Entergy Operations, Inc.

2CAN060306

SUBJECT: License Amendment Request
To Revise the Spent Fuel Pool Loading Pattern
Arkansas Nuclear One, Unit 2
Docket No. 50-368
License No. NPF-6

Analysis of Proposed Technical Specification Change

FIGURE 3.9.2
MINIMUM BURNUP VS. INITIAL ASSEMBLY AVERAGE U-235 LOADING

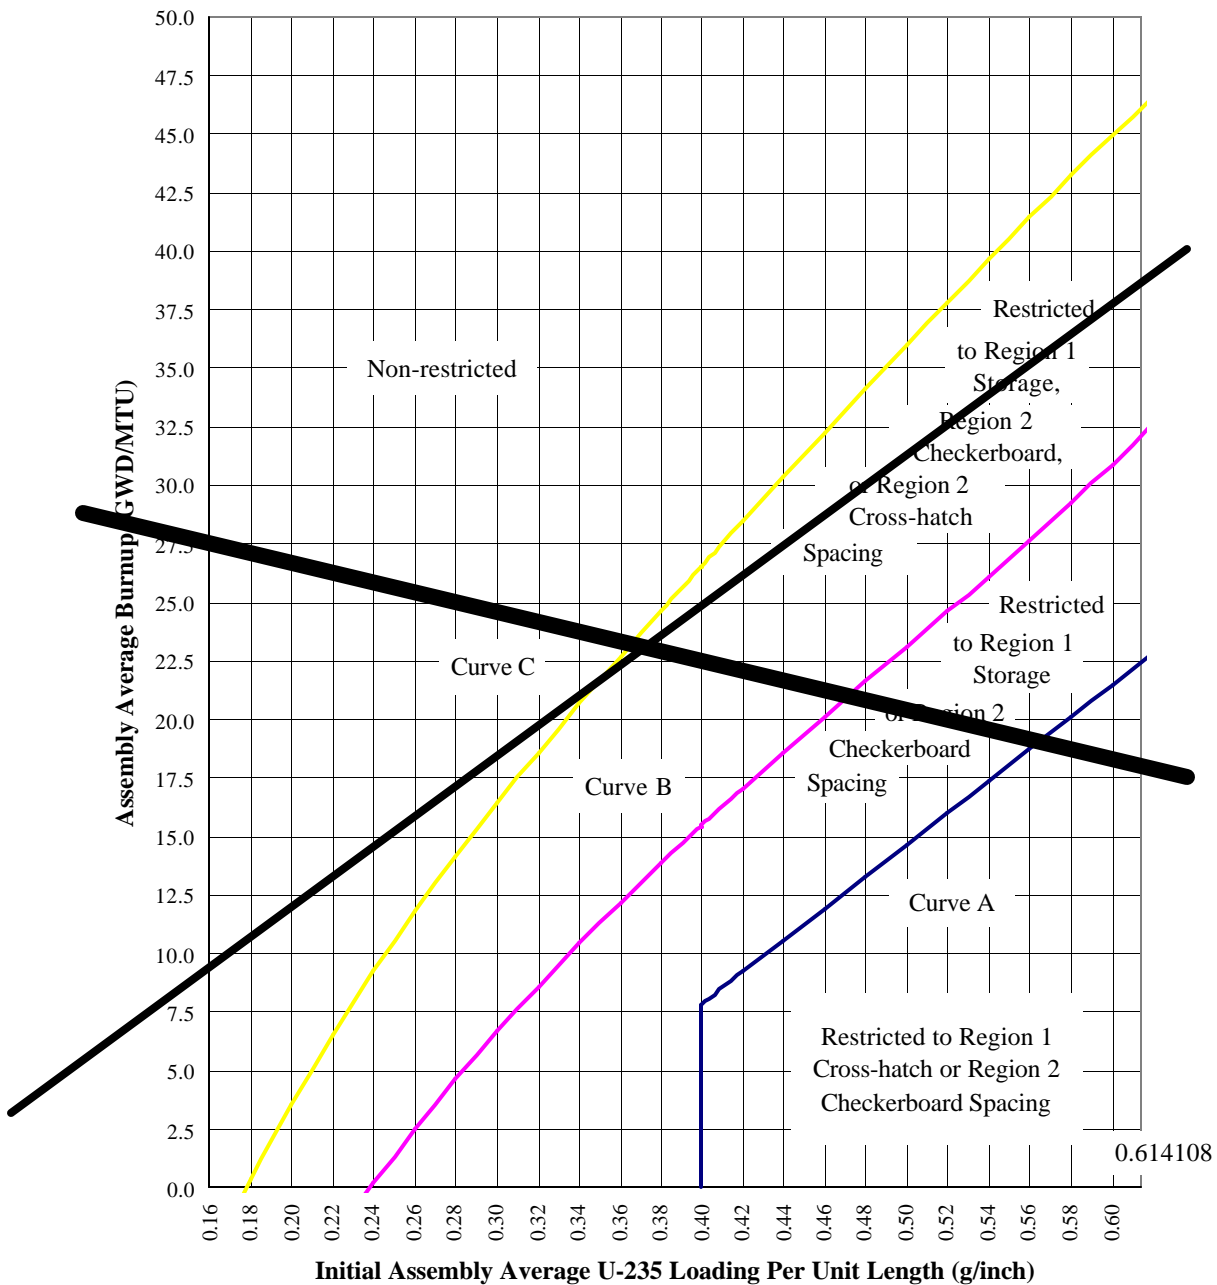
The current minimum burnup versus initial assembly average U-235 loading curve depicted in TS Figure 3.9.2 will be deleted. New information reflecting the allowable 2 x 2 loading patterns, the acceptable interfaces between the five patterns, the minimum burnup requirements of type “A” and “C” assemblies at varying enrichment and cooling times, and bounding polynomial equations used to determine the minimum acceptable burnup for type “A” and “C” assemblies will be added as the proposed TS Figure 3.9-2.

TS Figure 3.9.2 was subsequently modified with the approval of TS Amendment 178 (NRC SER dated January 14, 1997). This amendment allowed an increase in the initial fuel enrichment from 4.1 weight percent (w/o) to 5.0 w/o. The criticality analysis performed based on the higher initial enrichment resulted in changes to TS Figure 3.9.2. TS 3.9.12.a. was also modified.

TS Amendment 224 (NRC SER dated October 24, 2000) allowed an alternate storage configuration of fuel assemblies adjacent to the walls within Region 1 of the SFP provided they were less reactive than the area of the graph enclosed by Curve A on TS Figure 3.9.2. This change provided 17 additional storage locations. This allowance was incorporated with the insertion of Note 1.

Figure 3.9-2

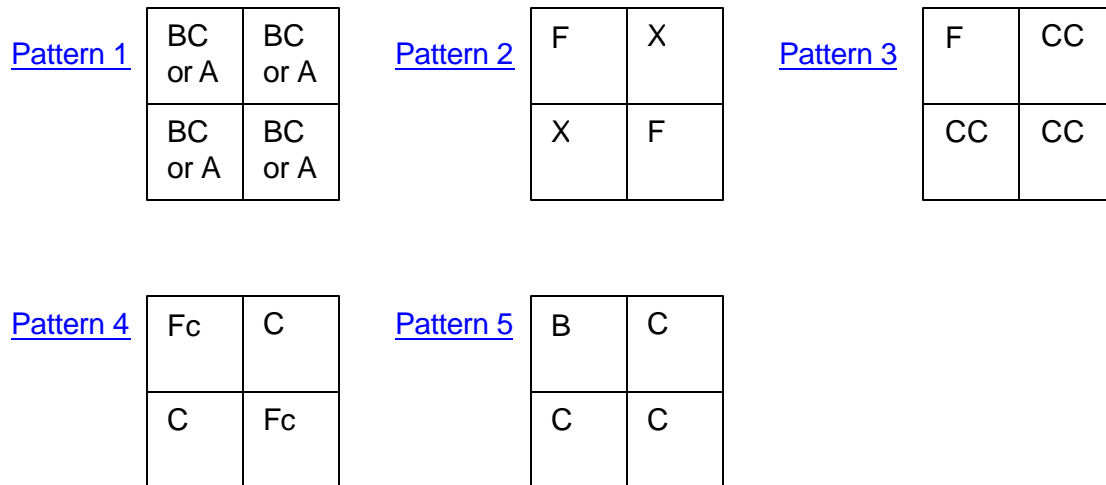
The five loading patterns, which will be reflected in TS Figure 3.9-2, have been evaluated to consider the reactivity effects based on various interfacing combinations. The allowable pattern interfaces will also be reflected in TS Figure 3.9-2.

Racks must be loaded using one of the five patterns shown in Figure 3.9-12. The type “A” and “C” assemblies have restrictions which are designated in Tables 1, 1-1, 2, and 2-1 of Figure 3.9-2. In any pattern, a less restrictive assembly may be substituted for another assembly within the pattern.

For adjacent patterns, both inside and between racks in the SFP, only the allowed interface configurations shown in Figure 3.9-2 may be used.
